APPLICATION NO.	FILING DATE	FIRST NAMED INVENTOR	ATTORNEY DOCKET NO.	CONFIRMATION NO.
09/768,271	01/25/2001	Tsukasa Yajima	PNET.009D	3802
20987	7590	09/27/2006	EXAMINER	
VOLENTINE FRANCOS, & WHITT PLLC ONE FREEDOM SQUARE 11951 FREEDOM DRIVE SUITE 1260 RESTON, VA 20190			MAI, ANH D	
			ART UNIT	PAPER NUMBER
			2814

Advisory Action Before the Filing of an Appeal Brief	Application No.	Applicant(s)
	09/768,271	YAJIMA, TSUKASA
Examiner	Art Unit	
Anh D. Mai	2814

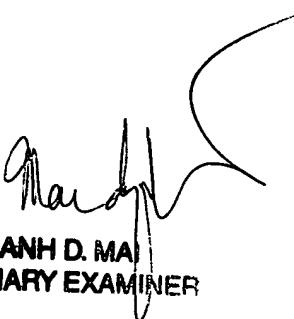
Claims rejected under 35 U.S.C. 112, first paragraph:

At best, the instant protective layer 12 is planar because it was CMP. Applicant appears to contend that drawing support for "substantially uniform thickness". However, the field oxide never has a planar surface as depicted in the drawing, see JP 02-257637, IDS. Therefore, the specification must explicitly indicated that the thickness of the protective layer is substantially uniform.
